Planning Commission Vote Report

Subject: Change of Zoning Vote Report

Meeting Date: January 25, 2010

Petition: P.Z. 15-2009 Chesterfield Airport Commerce Park (Insituform Technologies Inc.)

CHESTERFIELD AIRPORT COMMERCE PARK
PRELIMINARY PLAN

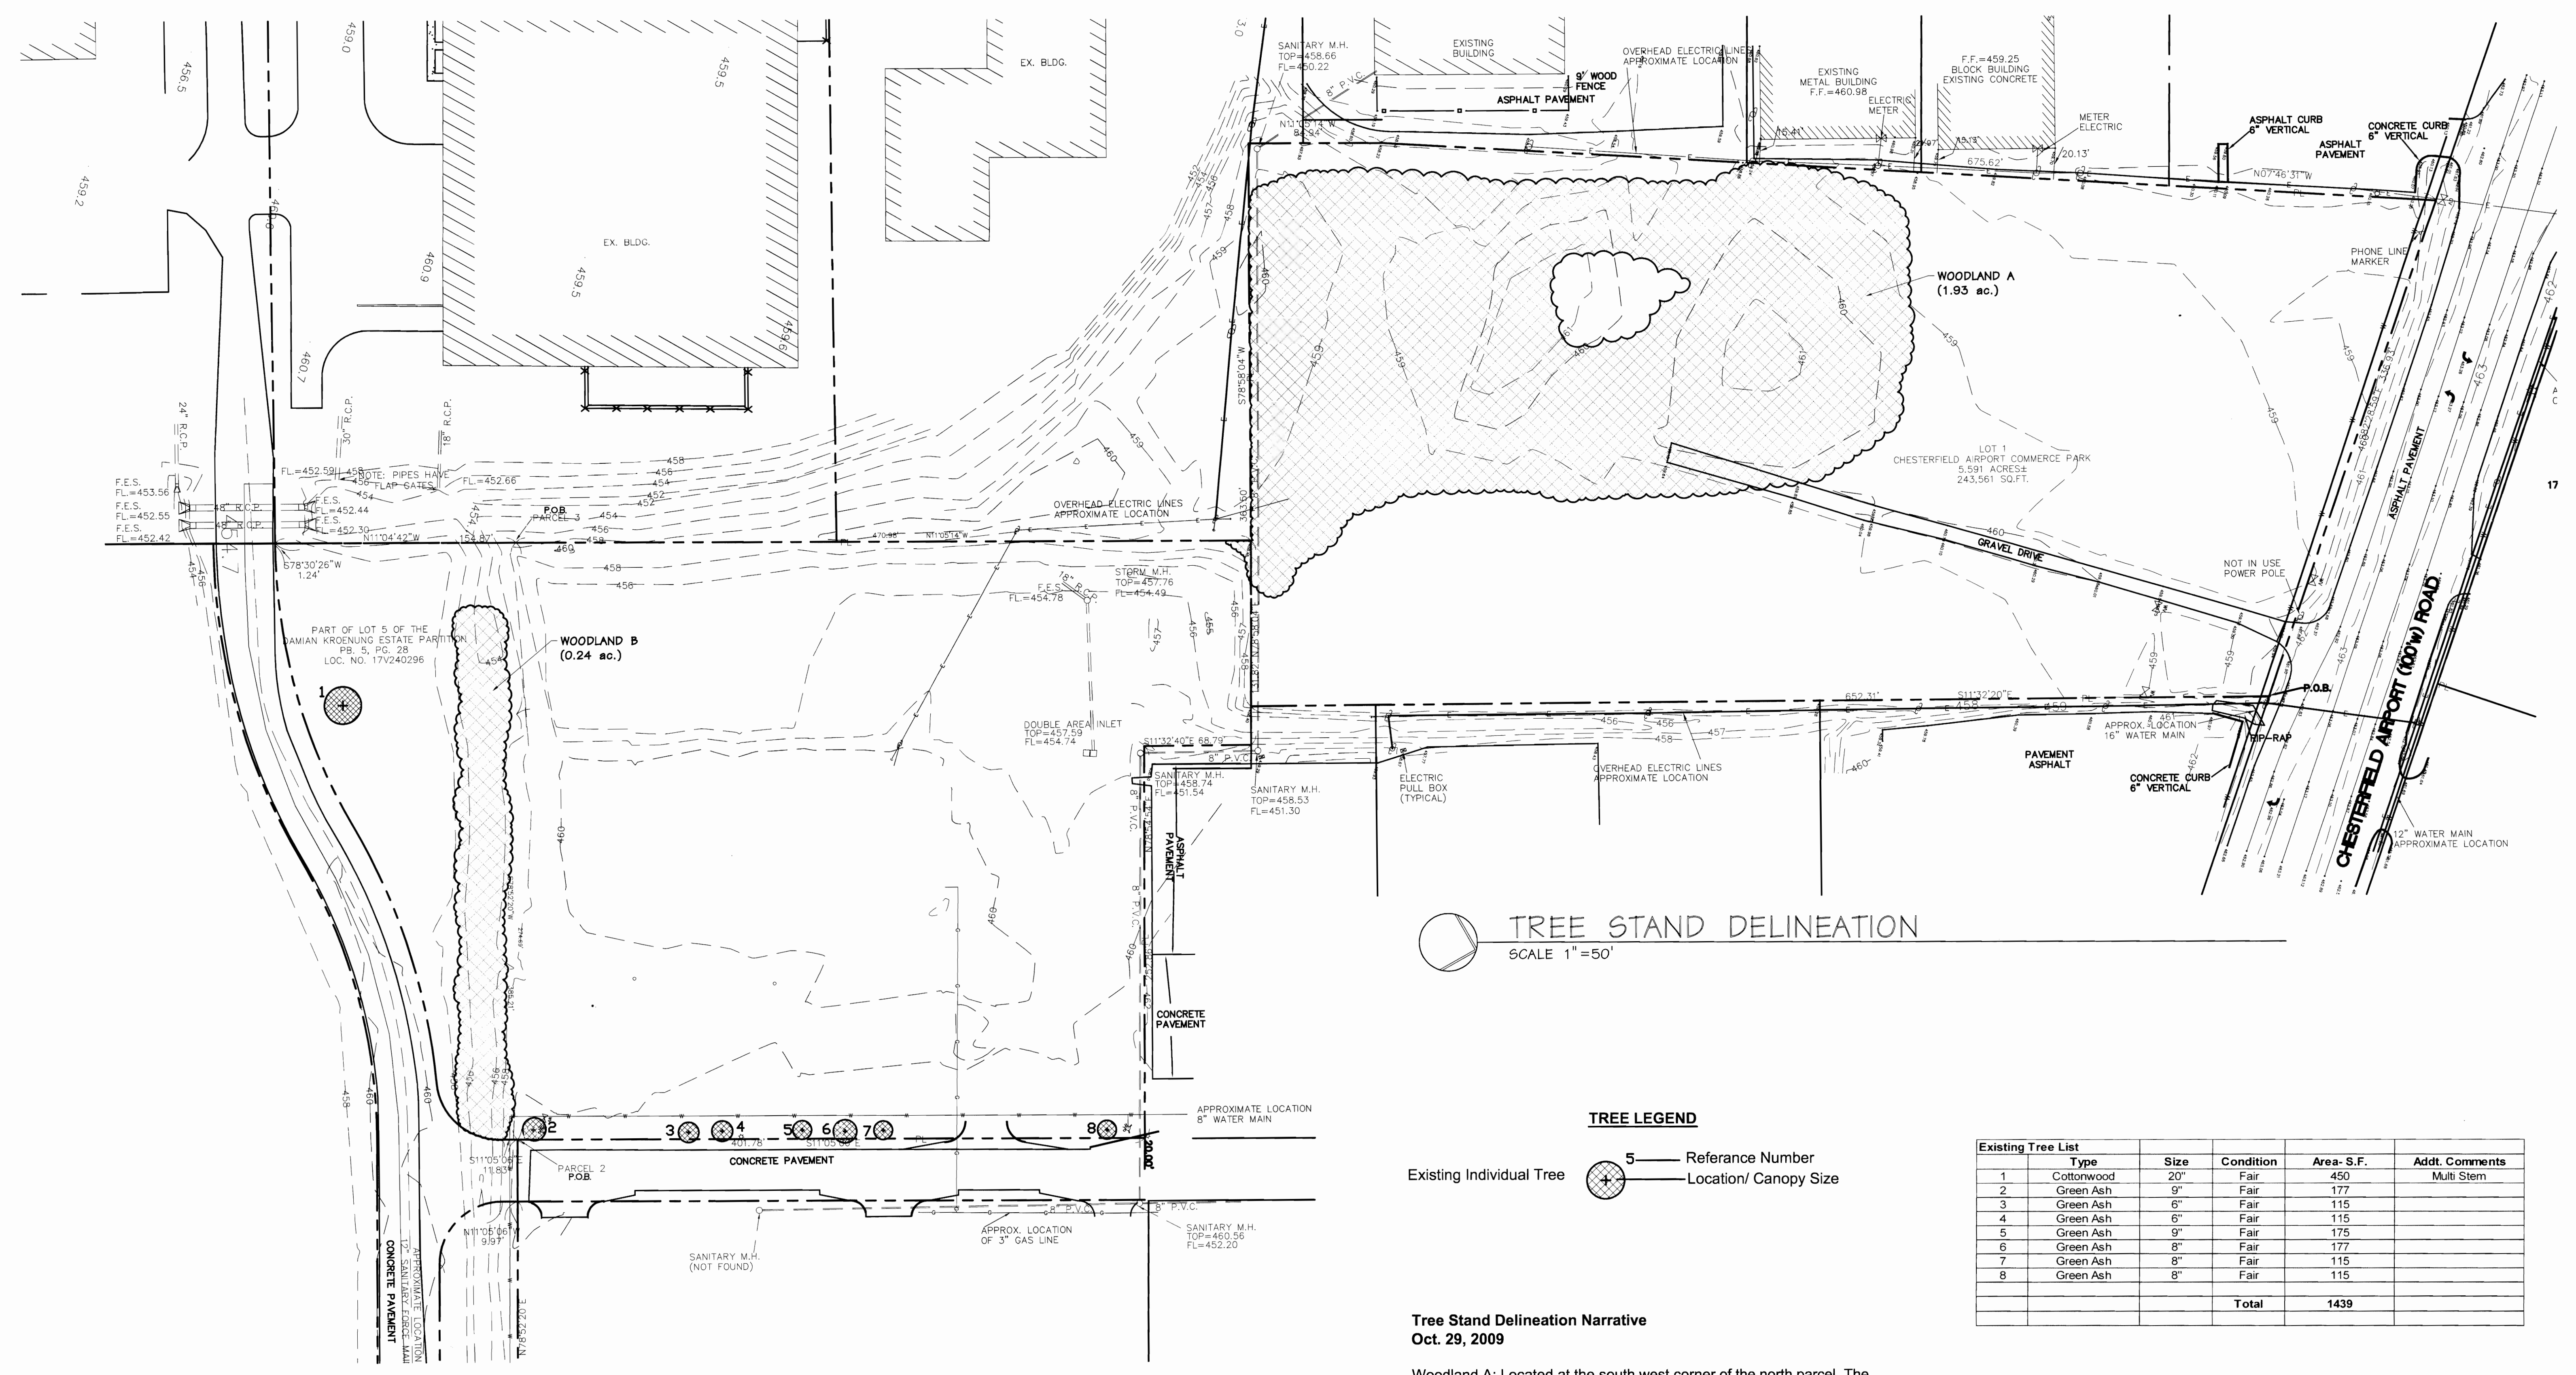
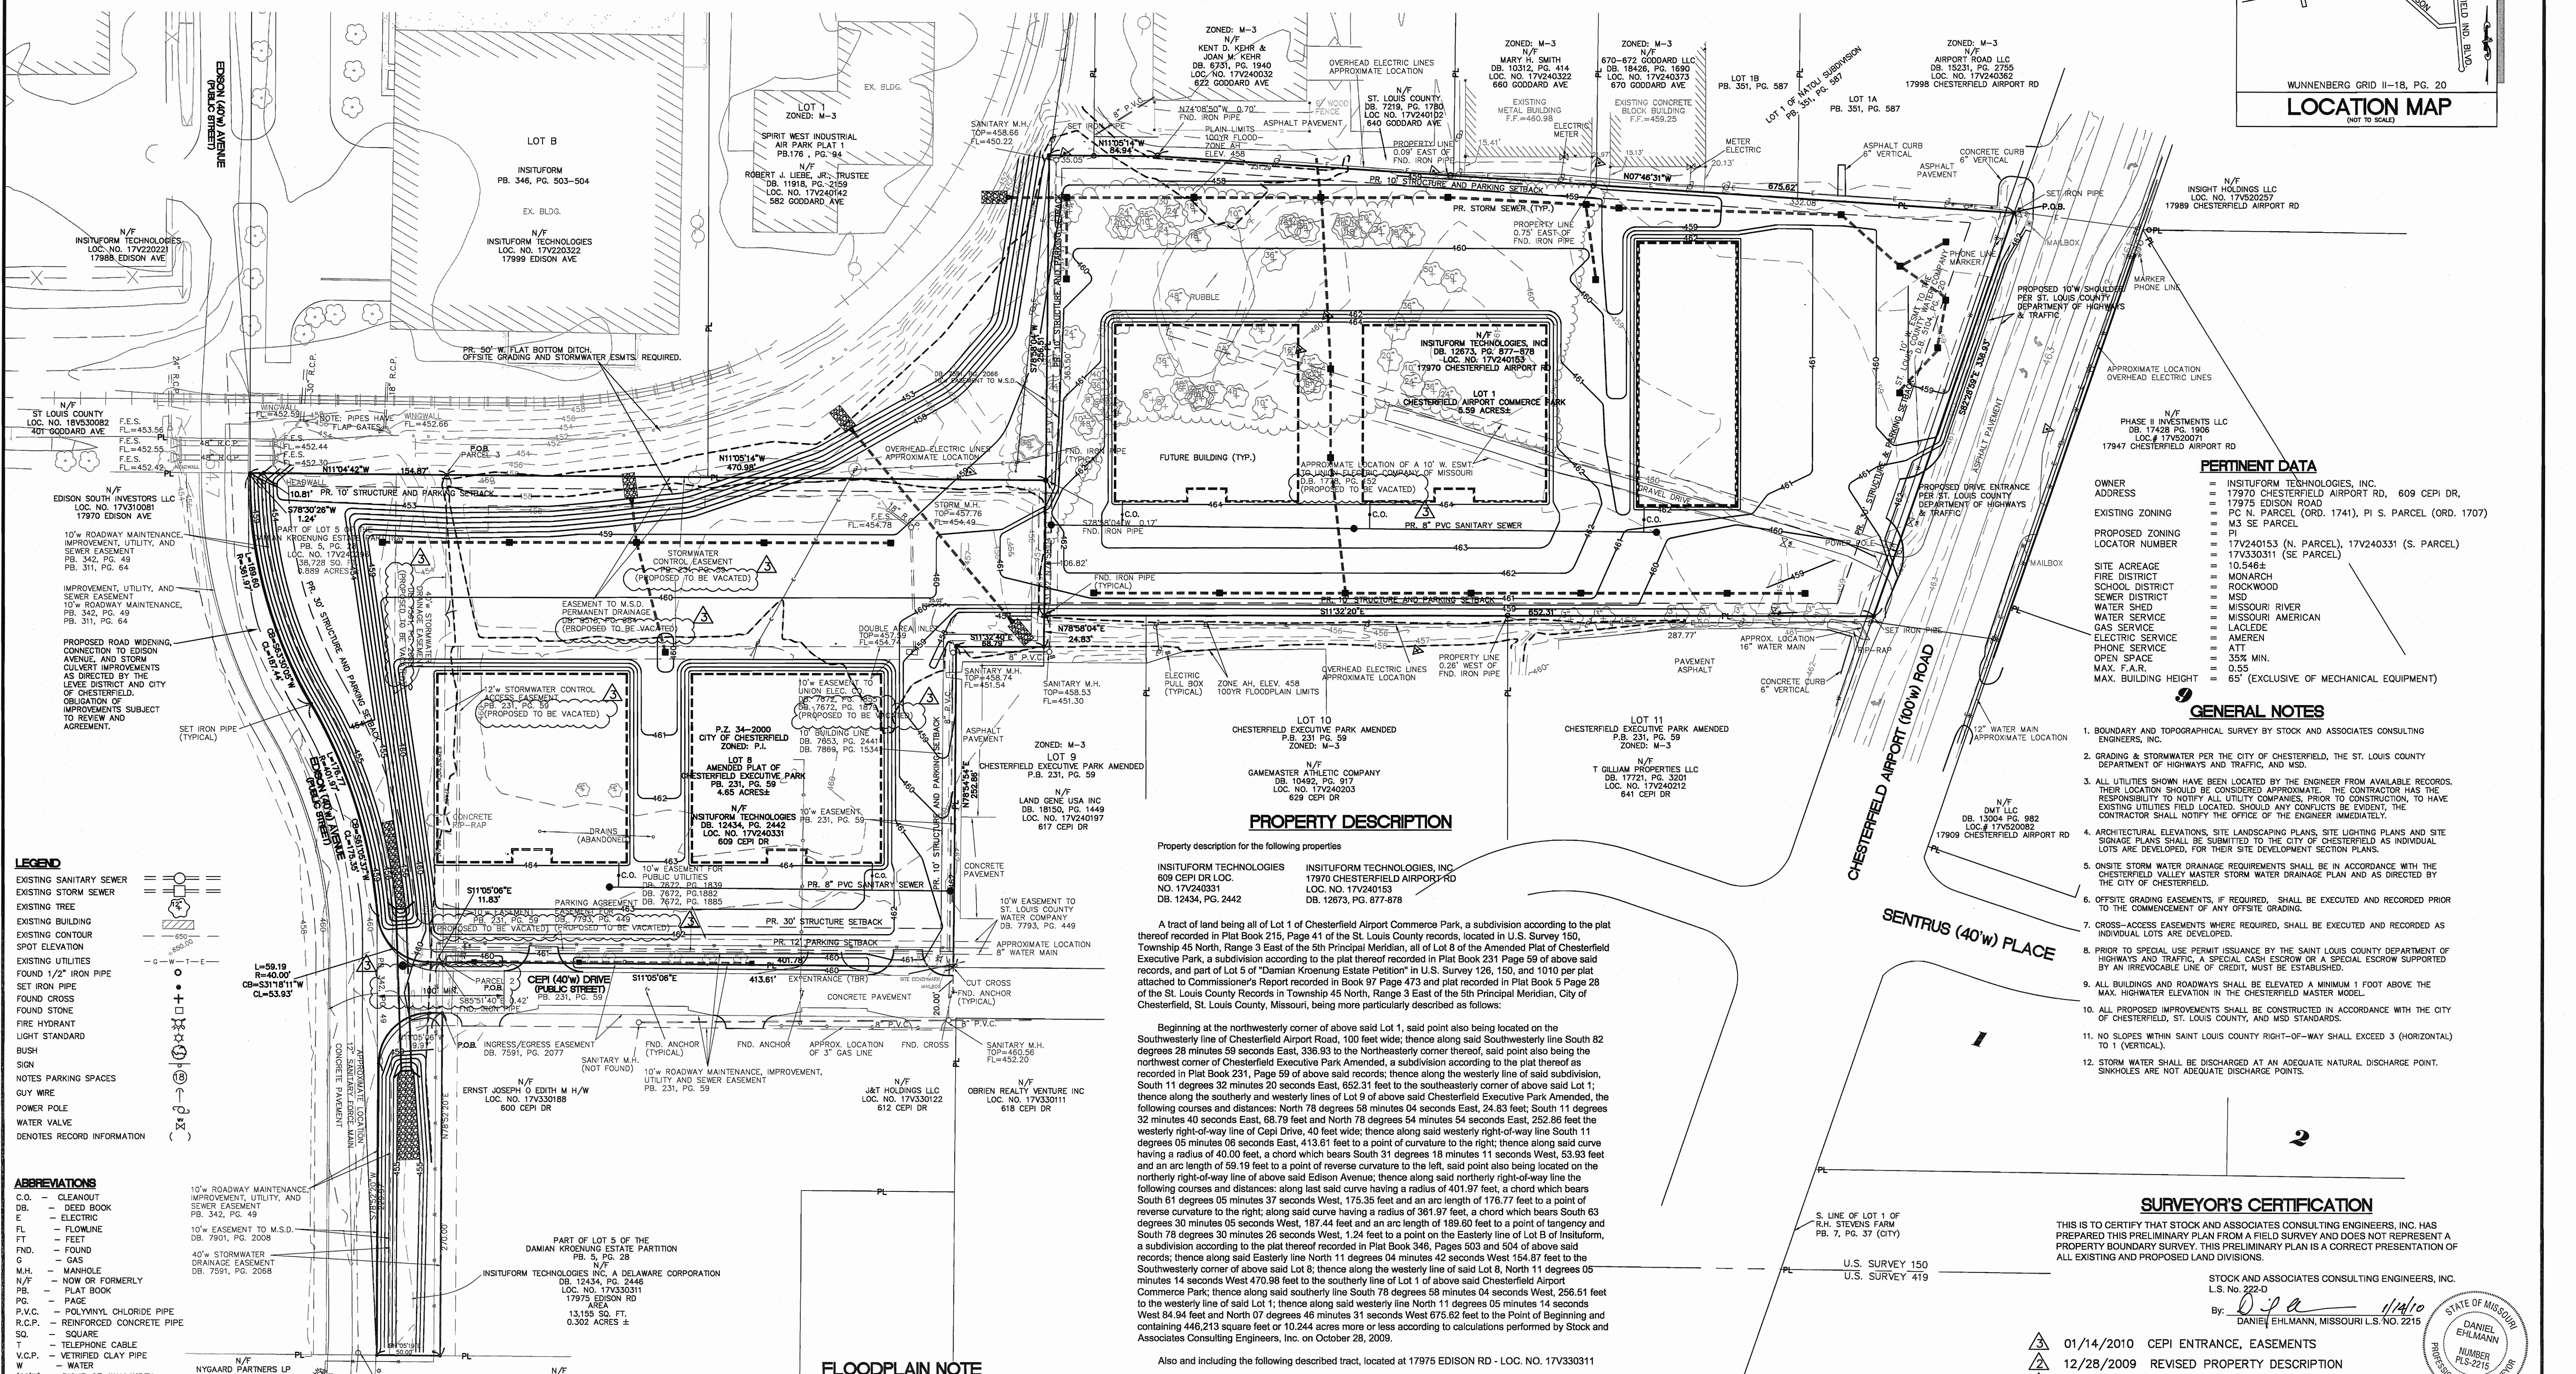
1. The petitioner was asked to revise the Preliminary Plan so that the access point(s) along Cepi Drive comply with the City of Chesterfield Access Management requirements. The petitioner has moved the drive aisle edge of the proposed southern most entrance to 100' off the proposed Edison Avenue 'edge of pavement'. Additionally, they have identified the existing driveway to be removed. These items have been revised on the Preliminary Plan.
